Proposal for Supplement 7 to the 01 series of amendments to Regulation No. 55 (Mechanical coupling)

Submitted by the Working Party on Brakes and Running Gear*

Supplement 7 to the 01 series of amendments to Regulation No. 55 (Mechanical coupling)

Figure 27

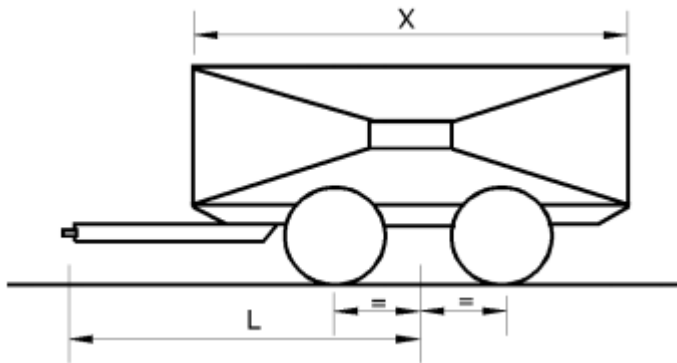
X is the length of the loading area of the trailer, in meters (see Figure 27)

L is the distance from the center of the drawbar eye to the center of the axle assembly, in meters (see Figure 27)

$$V = \frac{a \cdot C \cdot X^2}{L^2} \text{ kN} \quad (\text{See the Note below})$$

Note: $\frac{X^2}{L^2} \geq 1.0$ (If less than 1.0, the value of 1.0 shall be used)

Figure 28

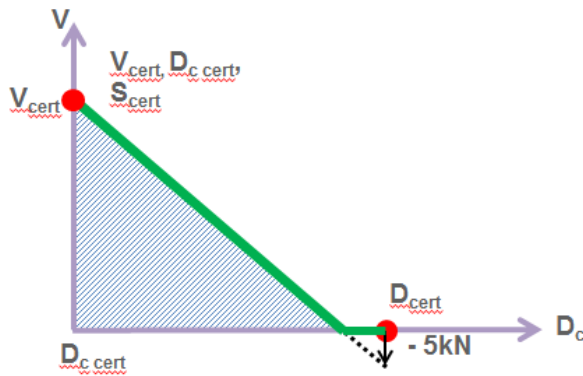
For each combination of certified performance values a diagram as shown in the Figure 28 may be drawn. Calculated performance value requirements D_{C-req} and V_{req} that would fall in the hatched area of the diagram are allowed to be operated in road traffic.

4.2. If the calculated performance value requirements fall within the hatched area of figure 28, the towable mass is verified with a limiting V-value. For the combination concerned the limiting V-value overrules the certified V-value of the coupling equipment installed.

4.2.1. The limiting V-value is given by a point on the sloping line in figure 28. This point corresponds to the D_c -value requirement calculated for the towable mass."
